Planning Commission Vote Report

Subject: Zoning Map Amendment

Petition: **P.Z. 01-2016 18600 Olive Street Road (Ezra Partners LLC)**

Re: PZ 01-2016
18600 Olive Street Rd (Ezra Partners LLC)
Volz Project No. 20862

PRELIMINARY DEVELOPMENT PLAN

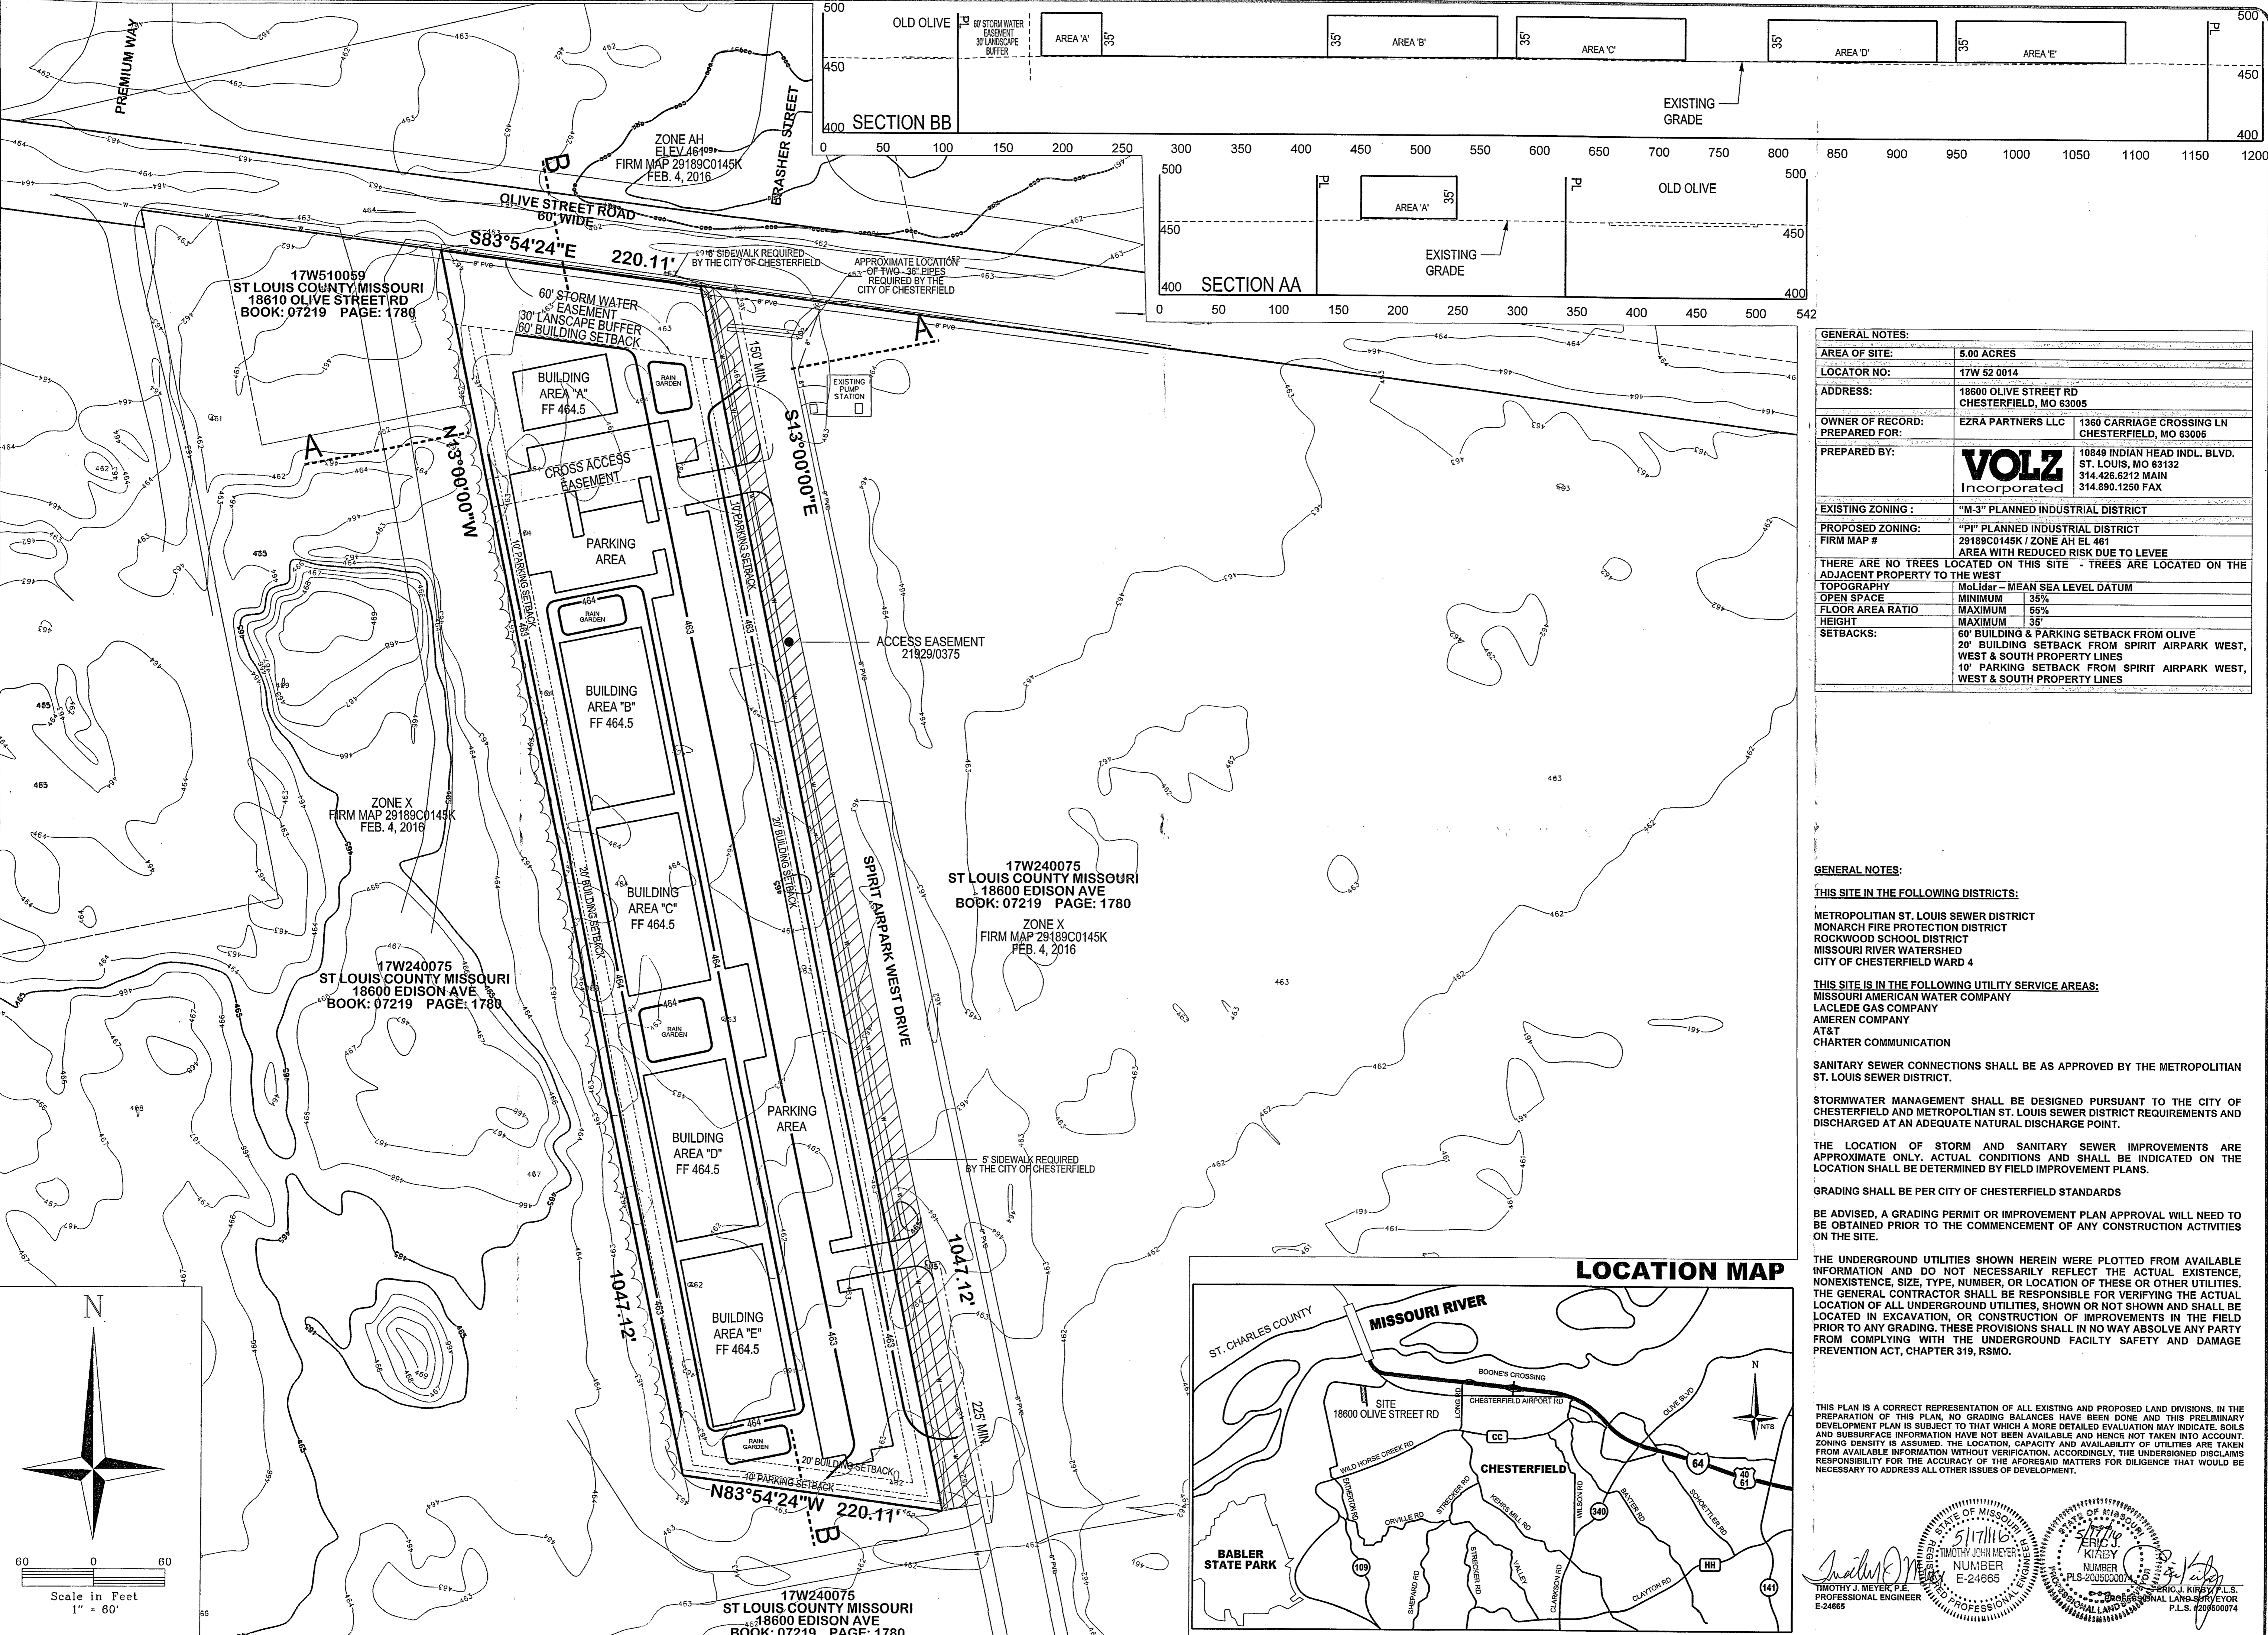
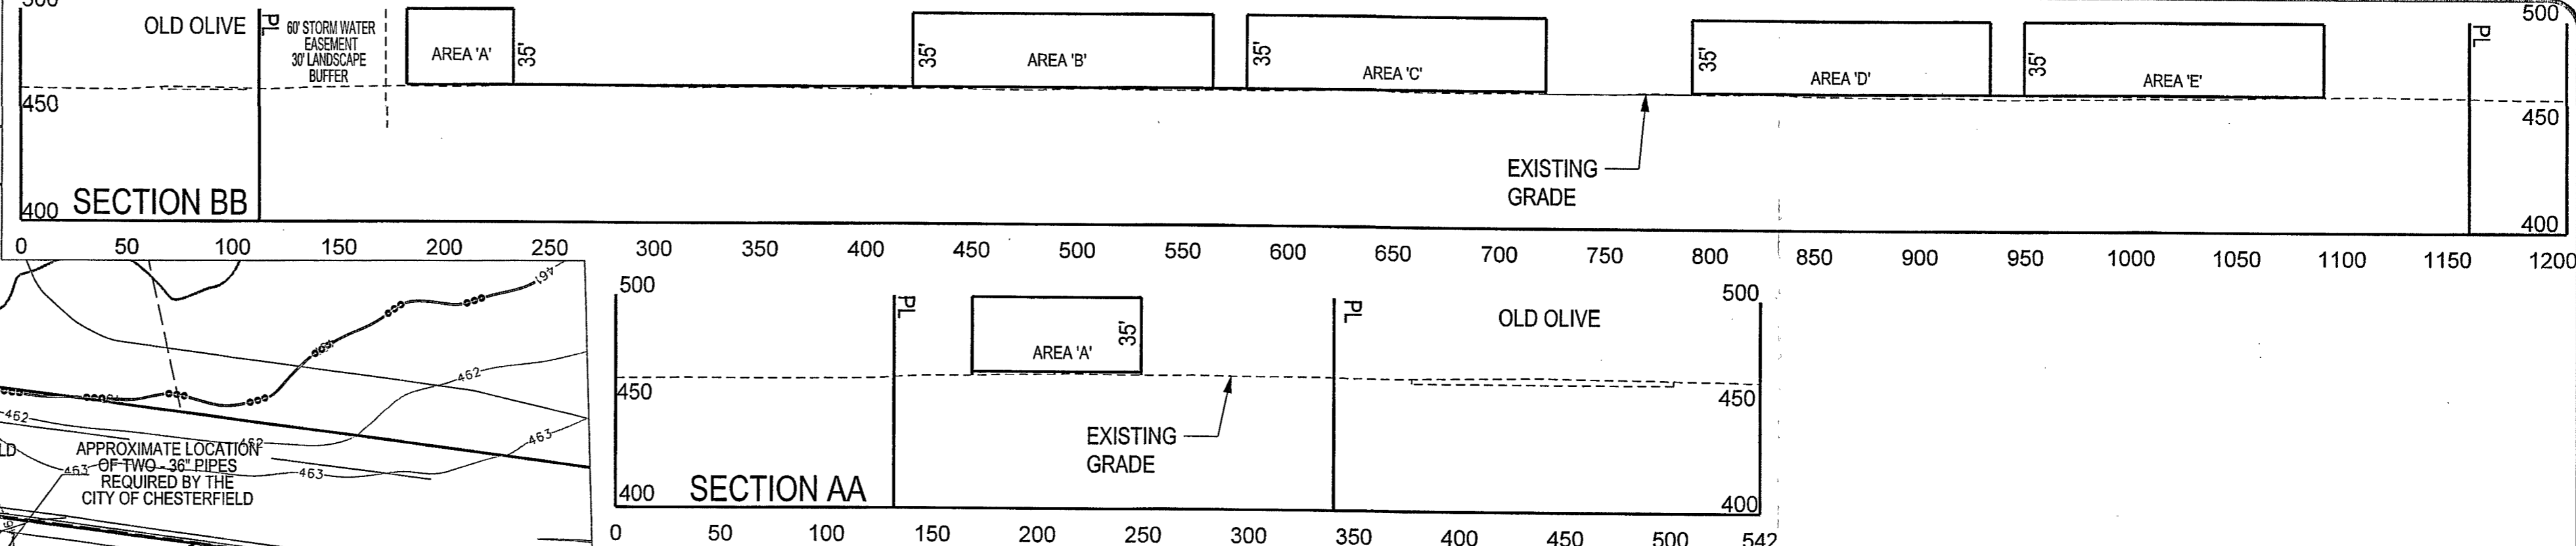
1. Per comments received from St. Louis County and provided to you, there is a 300' spacing requirement for drives when measured from Olive Street Road. Revise the plan to reflect this requirement.

2. Per comments received from Monarch Fire District and provided to you, there is a concern regarding access to the back of the buildings. Due to the narrow nature of this site, Staff wanted to call attention to this concern at this time rather than waiting until the Site Development Plan process. Please acknowledge this concern in your written response and revise the Preliminary Plan if needed.

3. Please provide a written response to Comments #2 and #3 from Metropolitan St. Louis Sewer District previously provided to you and dated March 4, 2016. Your response should state whether or not the various considerations have been made regarding the proposed rain gardens.

4. Staff has received the Access Easement Agreement between Ezra Partners, LLC and St. Louis County dated April 3, 2008. This existing easement should be depicted and labeled with the Deed Book and Page on the Preliminary Plan.

5. Depict Zone AH as shown on the FIRM Map 29189C0145K effective 2/4/2016 and label it with an elevation of 461 since the subject property is within 200 feet of this zone.

6. The proposed south access drive does not meet the City's minimum driveway spacing requirements. Revise the plan to ensure that the proposed drives meet all of the City's driveway spacing requirements.

7. The sidewalk along Olive Street Road appears to be directly adjacent to the Roadway Pavement. 6' sidewalk is required adjacent to the roadway.

8. In an effort to make it clear that the proposed F.A.R. and Open Space numbers are not the required numbers, include the minimum Open Space requirement of 35% and the maximum F.A.R. of 0.55 to the General Notes section.

9. Staff believes there is potential for the required 30' landscape buffer to overlap with the required 60' storm water easement. Due to the fact that the final design for the storm water facilities required by the Master Storm Water Plan along Olive Street Road will not be available until the Site Development Plan stage, the depiction of the 30' required landscape buffer should be removed from the Preliminary Plan. Be advised, however, that the applicant will still be required to meet all landscape and storm water requirements.

10. In conjunction with comment #7 above, the proposed structure setback along Olive Street Road may be proposed closer than the current 90' that had been discussed with Staff. Please review the proposed structure setback and revise on the Preliminary Plan as needed. Staff will review the proposal and it will likely be conditioned in the proposed Attachment A to be required to allow for consideration of both the storm water and landscape requirements as mentioned above.

St Louis County revised the requirement to a 150' spacing. This is more in line with the City of Chesterfield and has been reflected on the revised Preliminary Development Plan.

The two larger buildings have been split to better provide the access required by the Monarch Fire Protection District. This will again be reviewed during the Site development Plan stage.

A combination of rain gardens and pervious pavement will be provided if needed to treat the runoff from both the buildings and parking areas. The rain gardens have not been designed as yet, however sufficient area has been set aside so as not to compromise the foundation of the adjacent buildings. If needed the building foundations could be extended as well.

The Access Easement Agreement has been depicted and labeled on the Preliminary Plan.

Zone AH has been shown and labeled on the Preliminary Plan north of Olive Street Road per the FIRM map.

The south entrance has been revised to meet the City's minimum driveway spacing.

The sidewalk width has been revised to 6-feet. Final design will be shown on the Site Development Plan.

The minimum Open Space and maximum F.A.R. has been added to the General Notes.

Thank you. The separate 30 foot landscape buffer has been removed. We understand that this will be reevaluated during the Site Development Plan review.

The setback along Olive Street Road has been revised to 60 feet. We understand that this may change on the Site Development Plan based upon the storm water and landscape requirements.
